Basalt Waste Isolation Project
Comments on
Exploratory Shaft Drilling and Sealing

ENGINEERS INTERNATIONAL, INC.

Engineers International, Inc. (EI) has critically reviewed these documents with respect to four major areas of concern to the NRC:

Figure 1. Stratigraphy and mud losses, found in Borehole RRL-2 (from information provided in DOE ref. 10)

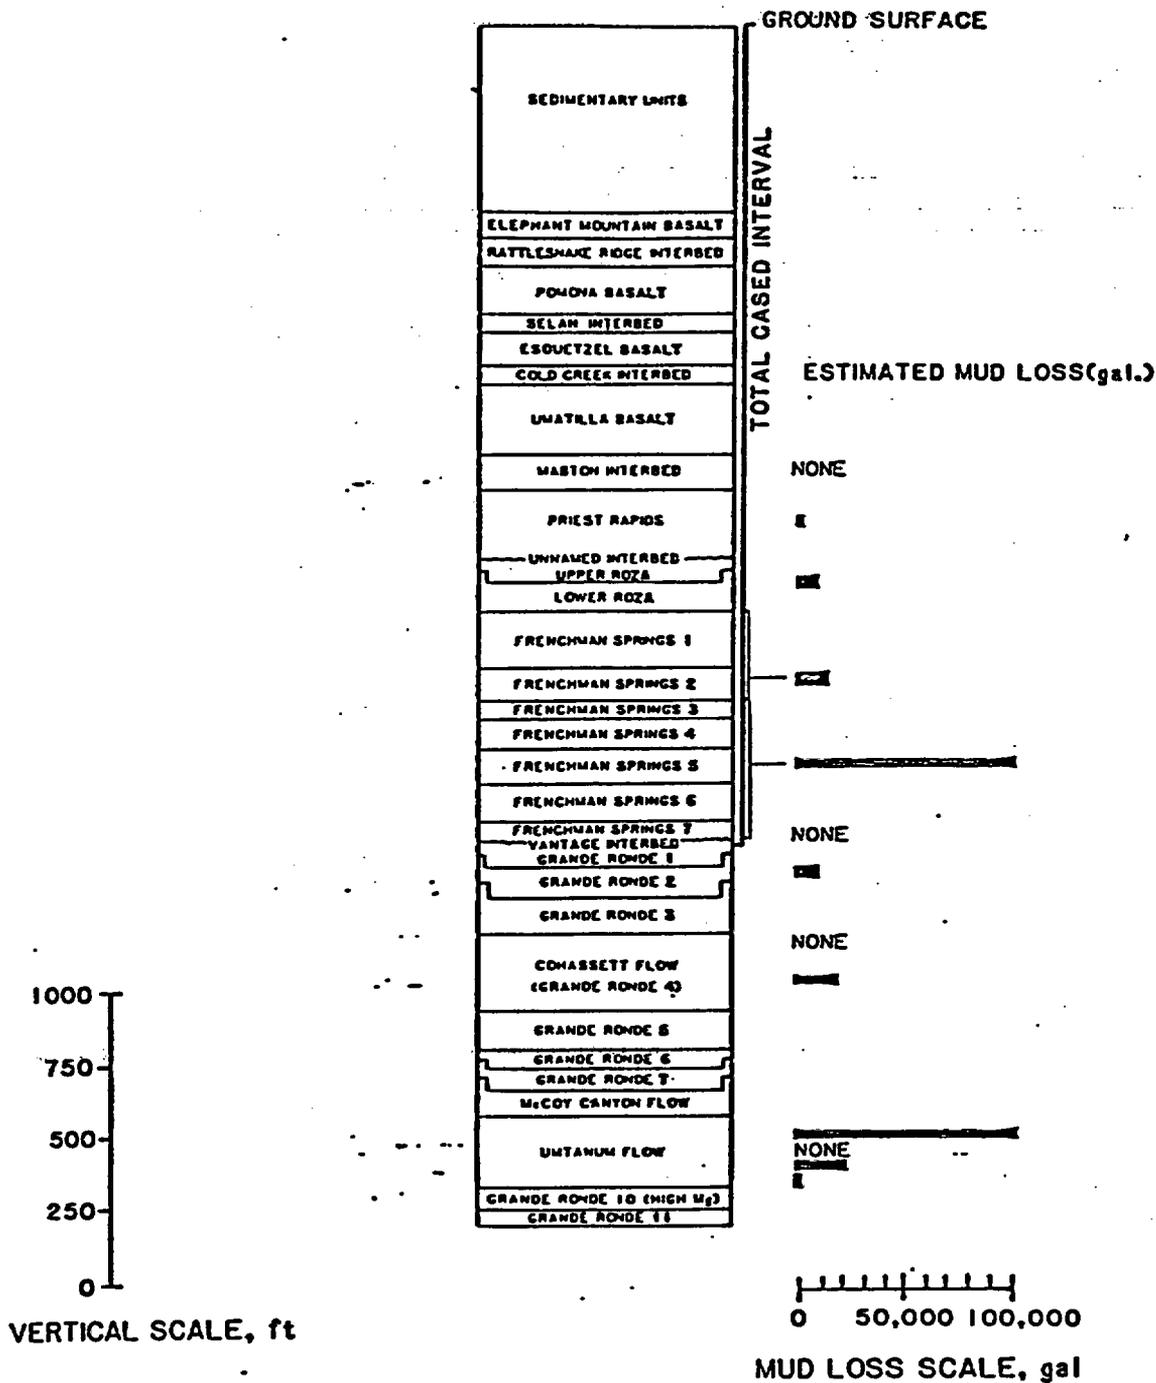
According to the Mud Loss Summary in the RRL-2 report, over 300,000 gallons of drilling mud were lost during the drilling of the principal borehole. Mud loss is an approximate indicator of formation permeability, and the Mud Loss Summary presents the quantities of mud that were assumed to be lost to each of the permeable formations encountered. Most significant is the large quantity of mud loss attributed to the Umtanum flow. Correlation between the mud losses in RRL-2 and other boreholes apparently has not been made. In addition, the RRL-2 report does not indicate how the mud losses within individual formations were determined or over what time span the losses occurred.

Hydrologic testing in RRL-2 indicates that permeabilities in most tested zones were slightly higher than had been estimated previously. There is no mention in the report regarding what effect the considerable mud losses might have had on subsequent permeability measurements. Accumulated clay and other drill mud materials could tend to decrease fracture permeability as determined by downhole testing (Greenslade et al, 1981). Figure 1 shows the location of the severe mud loss zones and the quantities of mud lost.

Formation and that sodium chloride type ground water was distinctive of Grande Ronde flows (Graham, et al., 1982). However, sodium chloride type ground water was found within lower Wanapum Formation flows in RRL-2. Hence, the previous belief that Grande Ronde Formation ground water is separated from the Wanapum Formation should be reexamined.

Figure 2. Schematic of the reverse air-assist circulation system (after Lackey, 1982)

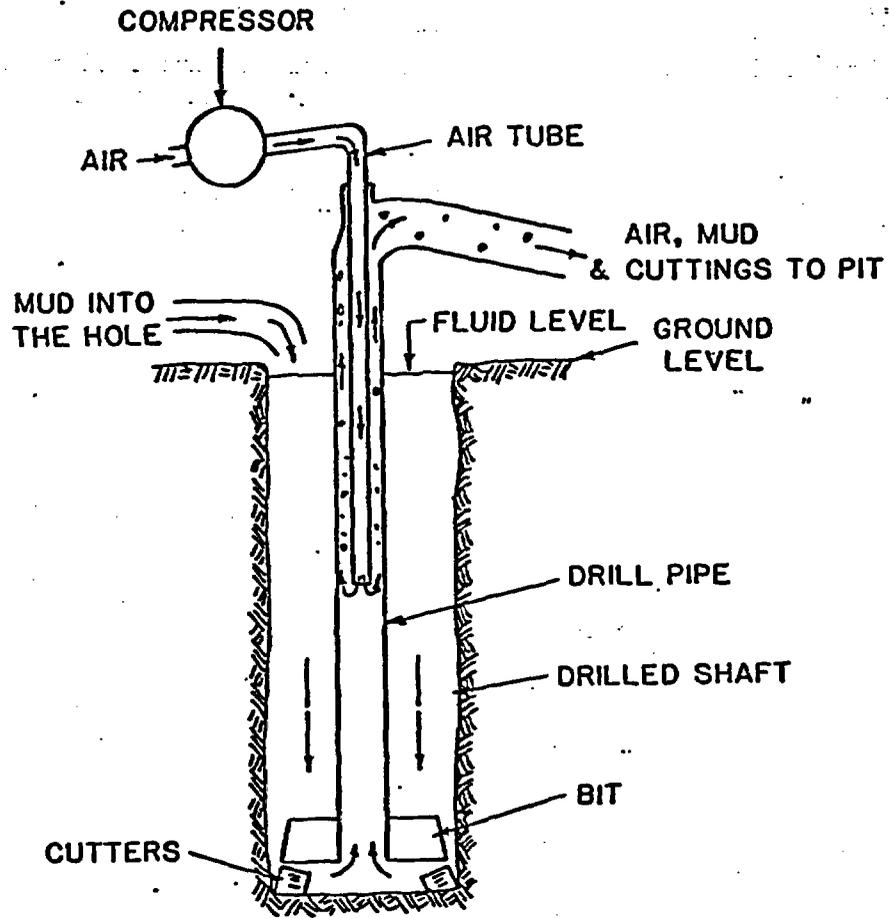
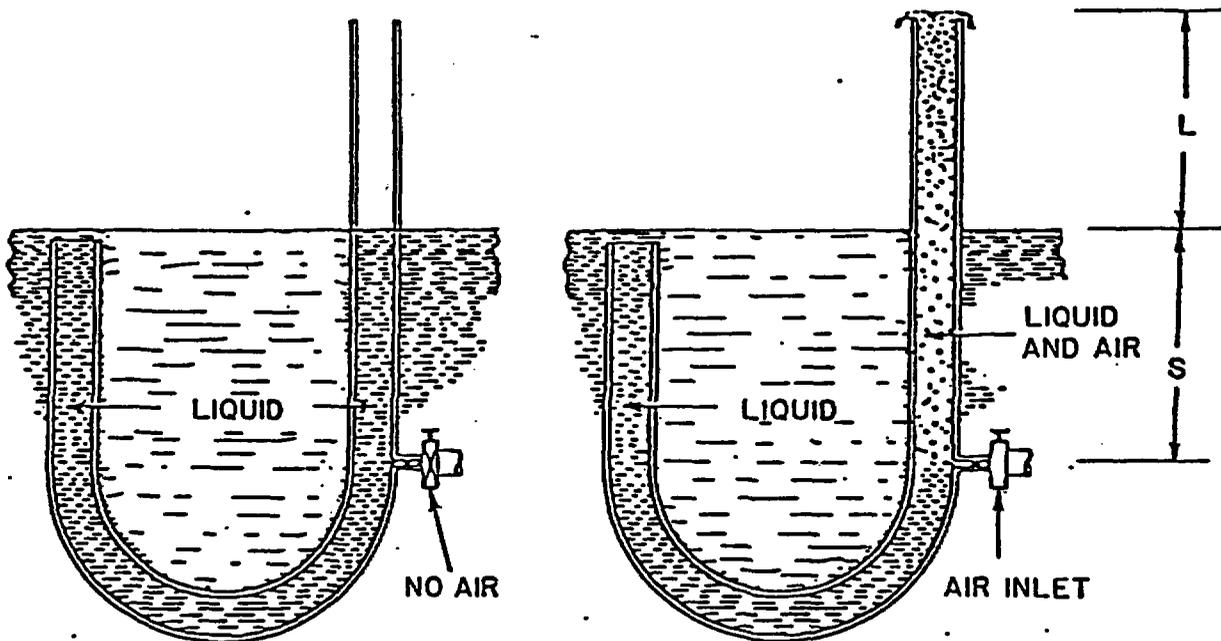
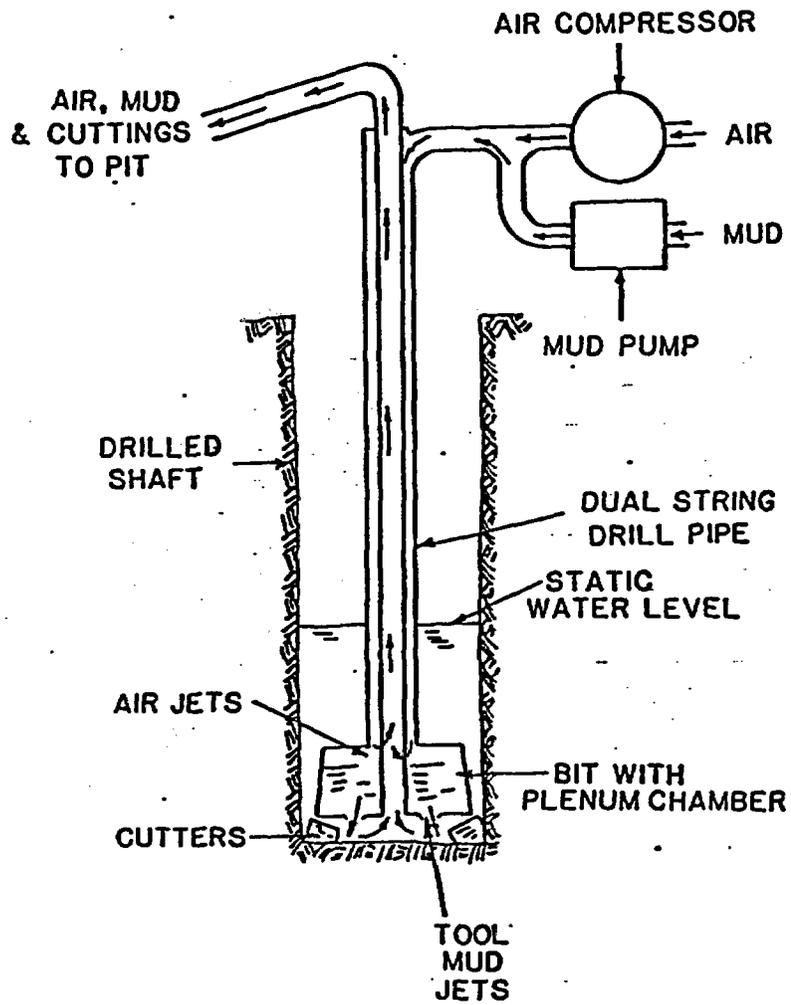
reference 1). The reverse air assist circulation system is illustrated in Figure 2. Drilling fluid is pumped into the hole and returns with the cuttings through the hollow drill string. Compressed air, which is introduced into the return mud through a "jet string" of small diameter pipe, lightens the column of fluid and provides the necessary lift. The principle of the air assist is shown in Figure 3.

With the reverse air assist circulation system, the hole must be kept filled with drill mud. The full column of mud has the beneficial effects of controlling water flow into the shaft and limiting wall rock sloughing. It is desirable to control the mud density so that the mud pressure is slightly greater than the formation pressure; hence, there is generally some mud lost to the formation.

Where excessive mud losses are anticipated, the dual-string circulation technique may be more effective. With the dual-string circulation technique, shown in Figure 4, mud mixed with compressed air travels to the drill bit through the annulus between the outer drill pipe and the inner string and returns up the inner string. A major advantage of this system is that the hole need not be kept completely filled with fluid, reducing the head driving the mud into the formation. Lackey (1982), feels that the dual-string system does a better job of cleaning the hole. However, for deep holes, high pressure compressed air is required to overcome losses and the hydrostatic head. This requires the use of large capacity compressors.

The shaft construction documents and contingency plans generally seem to be adequate. However, we feel that there has not been enough discussion of the effect of the chosen circulation technique (single-string reverse air-assist) on the formation, specifically the effect of the potential large mud losses on future hydrologic testing. A dual-string circulation system might be considered as a means to limit mud losses.
